## Hawaii Agriculture Research Center

Subj: Response to February 9, 2010 email  
NRC License No. 53-00515-01  
Docket No. 030-06839 Control No. 472404

Figure 15  
Fourth Floor Overview

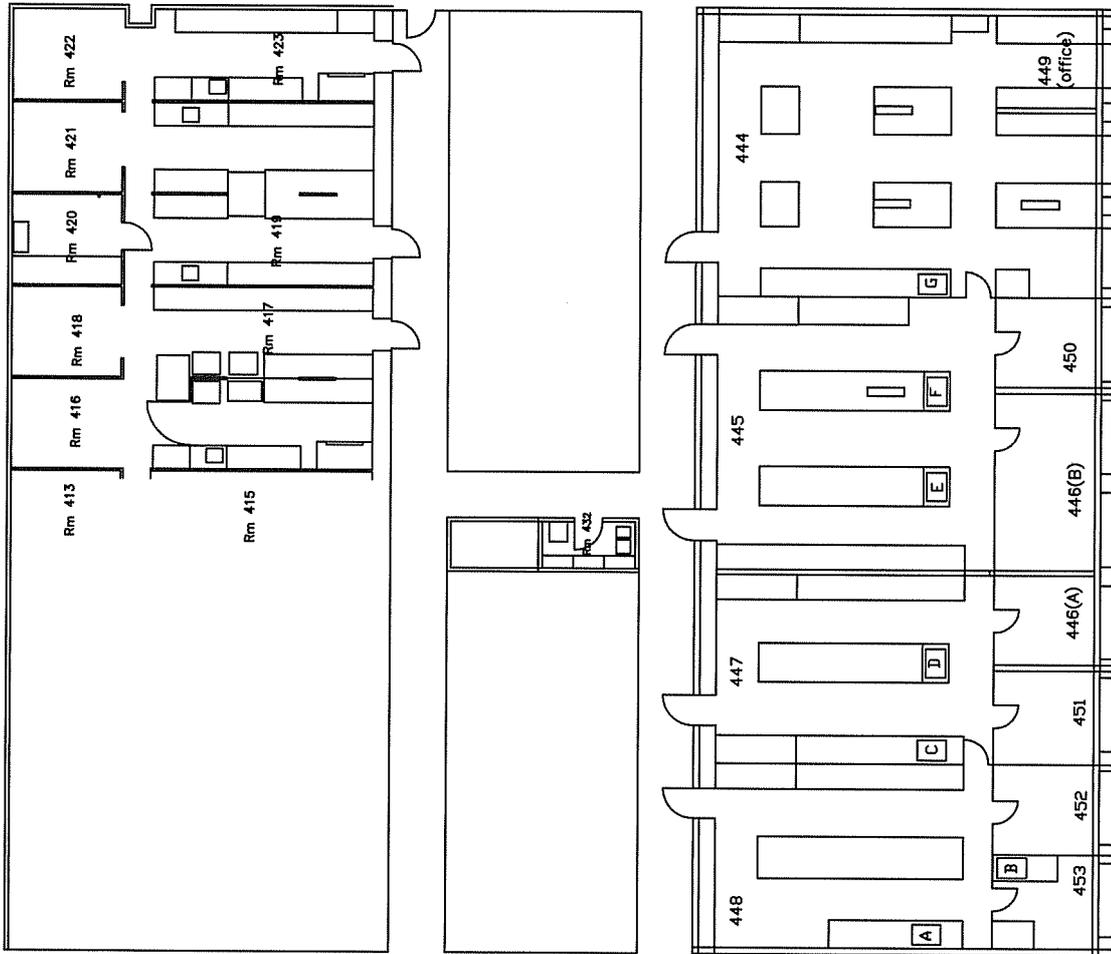
Figures 9.1-2 through 9.1-5, submitted to the NRC on November 8, 1994, are identical to Figures 9.1-1 through 9.1-4 submitted to the NRC by renewal application dated March 22, 2005. The rooms listed in the figures don't agree with the rooms mentioned in the September 8, 2009, letter. Figure 9.1-2 (9.1-1 in renewal application) includes rooms 229, 231, 234, 235, 236, 242 and 246. These rooms are not listed in the September 2009 letter. The figure for the third floor does not clearly show all rooms by number, so a room by room check could not be conducted. Finally, Figure 9.1-5 (9.1-4) shows rooms 413-416 which are not included in the September 2009 letter.

Rooms 413, 415, and 416 were never established as radioactive material use areas. Rooms 413 and 416 are offices, and Room 415 is an adjacent lab which was not a restricted area. Figures 15, 24, and 25 have been modified to show these room numbers, and are attached.

Figure 18  
LAB 447

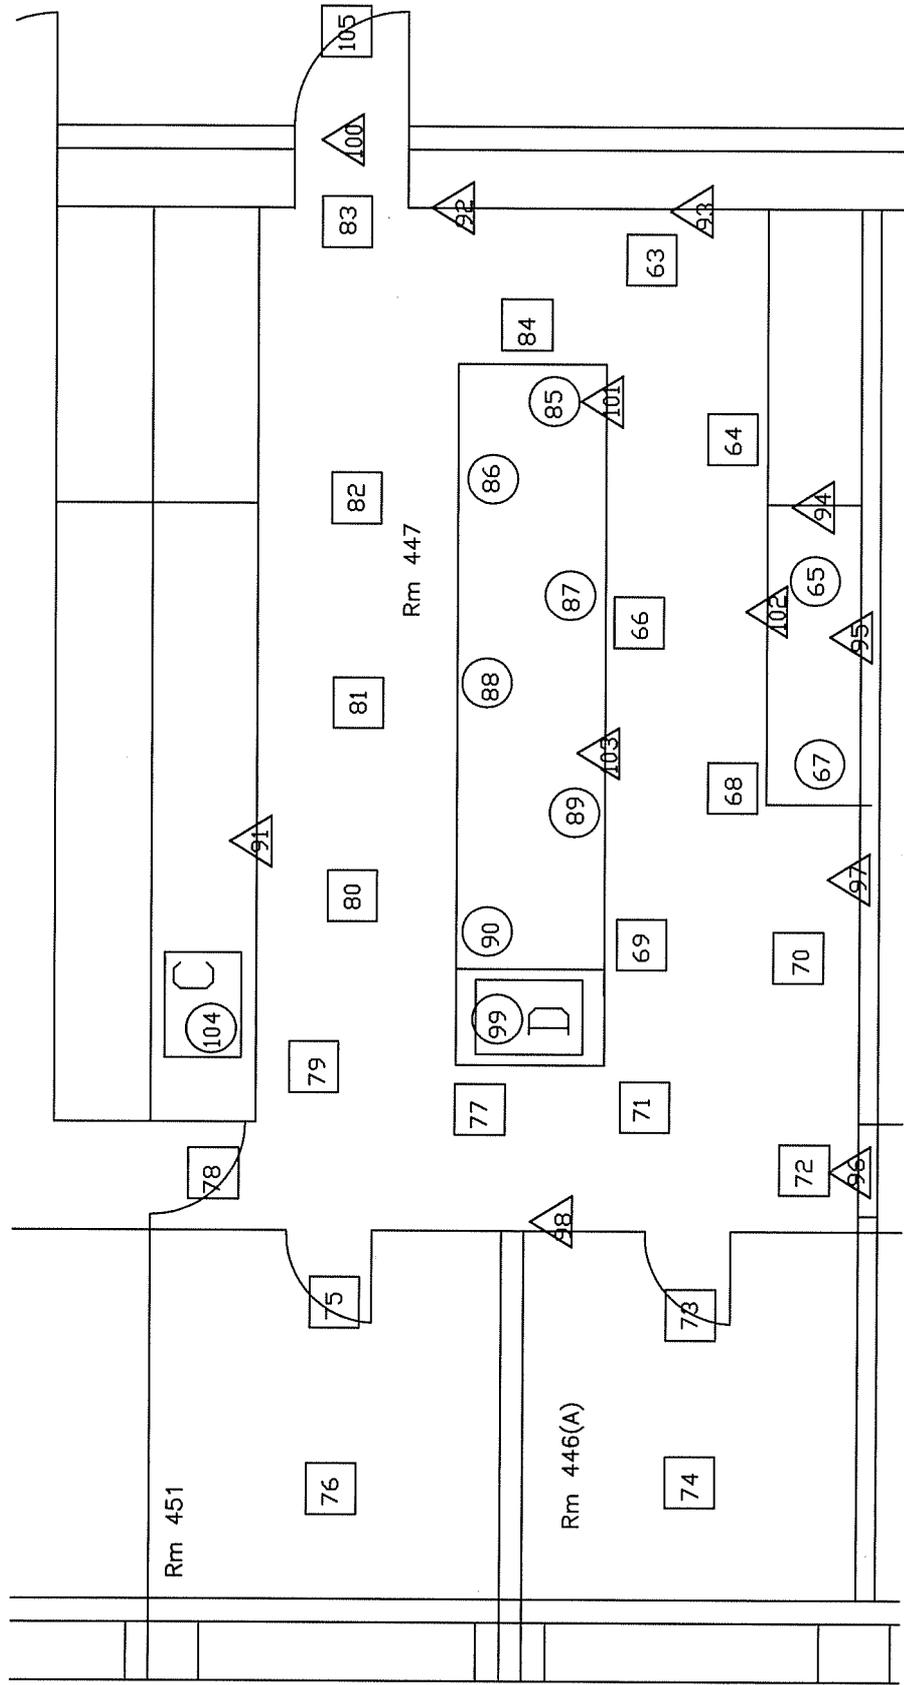
The original application dated July 25, 1975, for 99-193 Aiea Heights Drive included a statement that radioactive materials would be used in Rooms 444-448. Room 446 was specifically mentioned in the application. Only rooms 444, 445, 447, and 448 (not 446) were listed in later applications. The current status of room 446 is not clear.

The original diagram from the 1975 application doesn't include Rm 446 in the boundary of the controlled area. However, survey sheets from the 1980's indicate that a counter on one side of the room (closest to room 451) was included on routine surveys. This counter and floor were last surveyed on February 23, 1995 as part of a dis-establishing survey for this area. Radioactive material has not been used in this area since that time. This room was renovated and divided into two separate work areas in 2007. The drawings submitted with the decommissioning survey shows the new wall. Figures 15, 16, 17, and 18 have been modified to show the missing room numbers. The portion of room 446 closest to room 451 (now labeled as 446(A)) was surveyed and wipe tested during the final status survey, as shown in Figure 18.
